**ADDENDUM NO. 2 FOR BID NO. 11-8-23**

**RENOVATION OF FOUR (4) BASEBALL/SOFTBALL FIELDS AT JIM GOLDEN COMPLEX FOR CHATHAM COUNTY PUBLIC WORKS AND PARK SERVICES.**

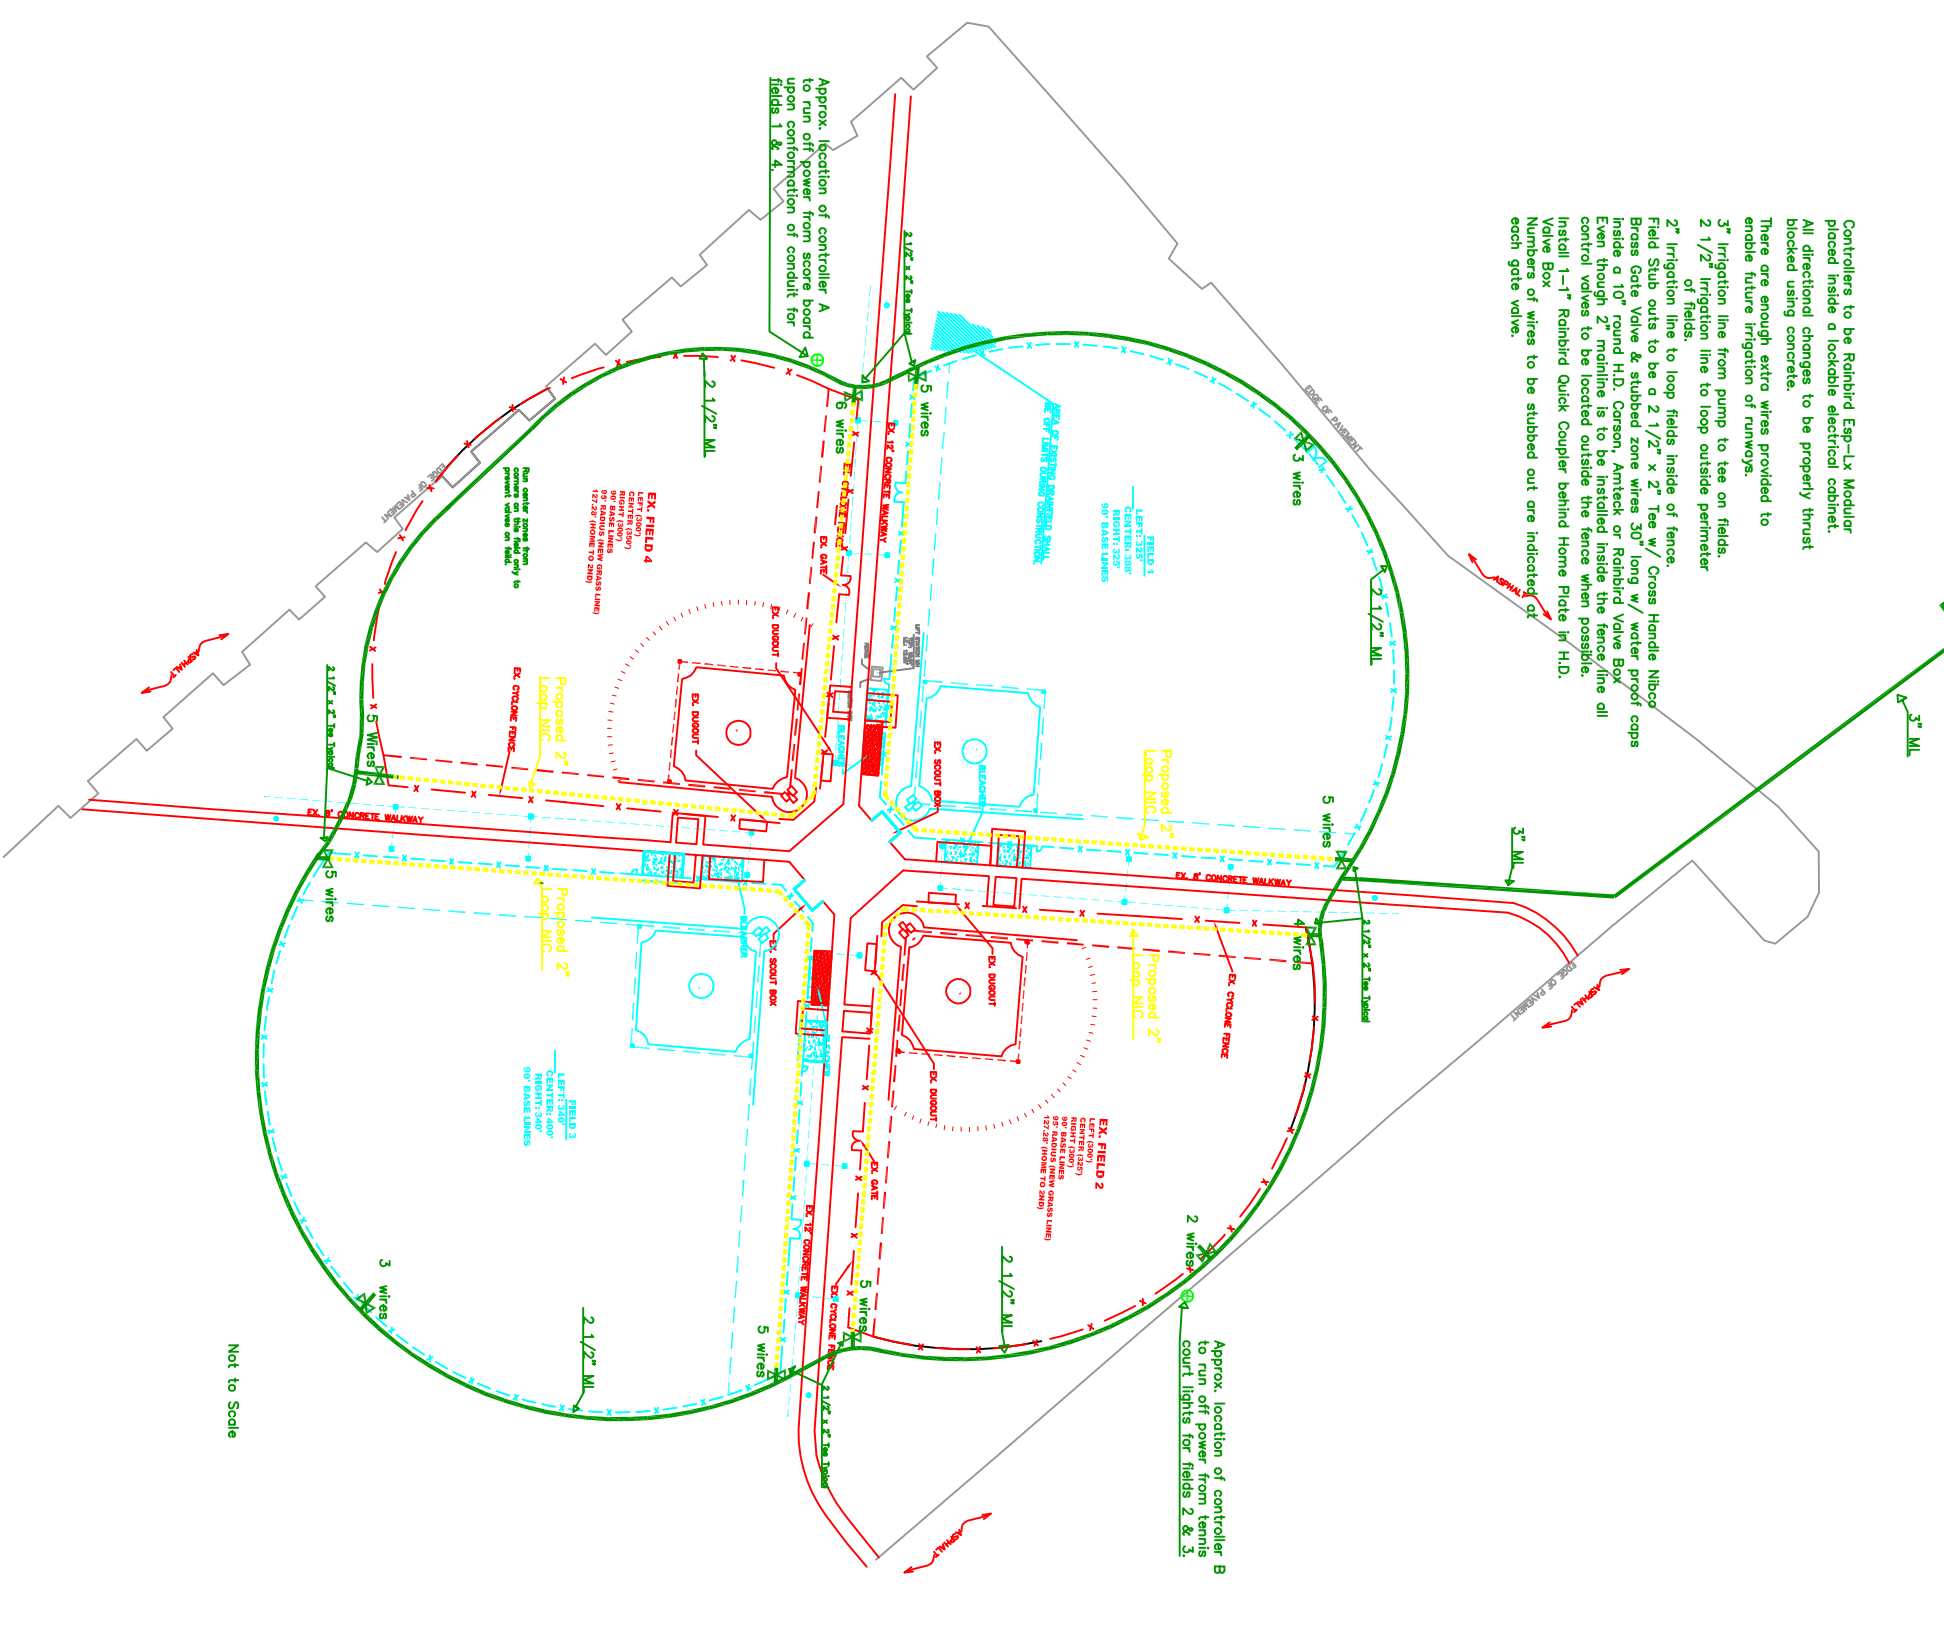
- A. Is there an available master plan for the ballfields? With a master plan we determine where the point of connection (well) is located, and the distance to each "tap in".

- B. The addendum mentions "taps ins" from a continuous loop on the outside of each out field fence, do you know the diameter of the looped pipe? By knowing the distance of the loop and the gallons per minute and pressure we can then size the pipe correctly.

- C. Are there dimensions on the ball fields? Specifically the distance from home to the right and left foul poles. Is it acceptable to over throw the fence that surround the ball field or are there future plans to make tracks or signs on the fence?

- D. Do you have the dimensions and locations on the bleachers so that we can determine the area of irrigated sod (length, width, depth)?

Ans. Attached is a PDF file of the four (4) ball fields at the Jim Golden Complex. The notes provide details of all the tap in and the size of the

Ans. Please see Ans No. A above.

Ans. Please see Ans. No. A above. The fence should not have anything on it. It is possible that the County will offer sign space for a fee to generate revenue.

Ans. Fields two (2) and four (4) will be sod from bleacher to bleacher. This is the area that runs from one bleacher behind the backstop to the other bleacher. Fields one (1) and three(3) will be from Dugout to Dugout. Again, it is the area behind the backstop. Please see the PDF file.

New 7.5 hp Booster Pump  
to be installed next to  
Water Tank

Controllers to be Rainbird Esp-Lx Modular placed inside a lockable electrical cabinet. All directional changes to be properly thrust blocked using concrete. There are enough extra wires provided to enable future irrigation of runways. 3" irrigation line from pump to tee on fields. 2 1/2" irrigation line to loop outside perimeter of fields. 2" irrigation line to loop fields inside of fence. Brass Stub outs to be a 2 1/2" x 2" Tee w/ Cross Handle Nibco. Brass Gate Valve & stubbed zone wires 30' long w/ water proof caps inside a 10" round H.D. Carson, Anteck or Rainbird Valve Box. Even though 2" mainline is to be installed inside the fence/line all control valves to be located outside the fence when possible. Install 1-1" Rainbird Quick Coupler behind Home Plate in H.D. Valve Box. Numbers of wires to be stubbed out are indicated at each gate valve.

Approx. location of controller A  
to run off power from score board  
upon conformation of conduit for  
fields 1 & 4.

Approx. location of controller B  
to run off power from tennis  
court lights for fields 2 & 3.

Place controller inside from  
to prevent wires on field.
